Questions/Small update

GTH Banks → 8 in total

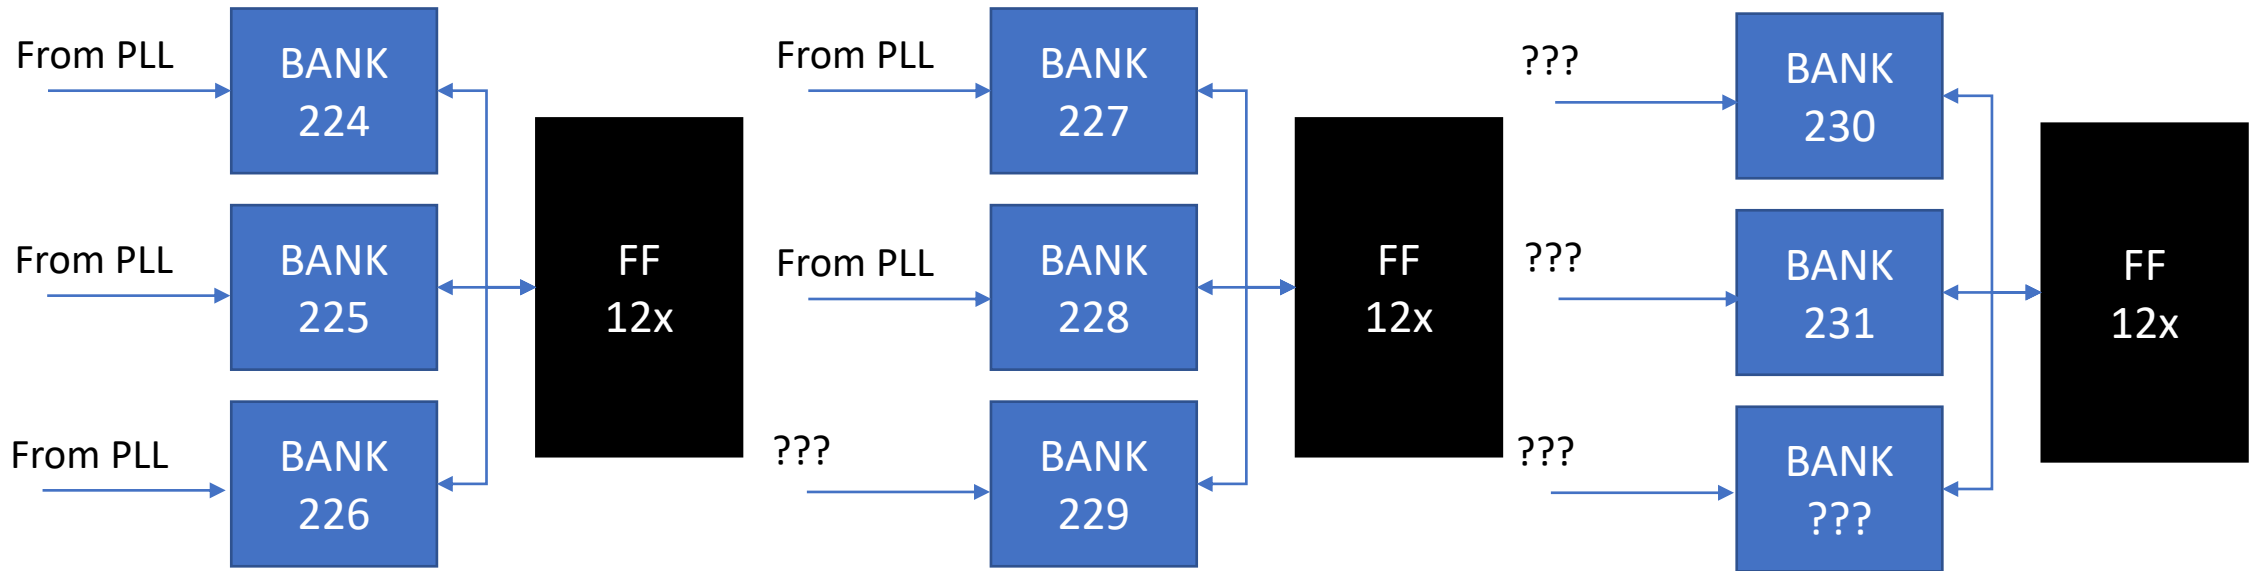
For all 12x FireFlies ideally 9 would be needed.

- Route one Quad of the FF to a GTY??
- Another FF 4x
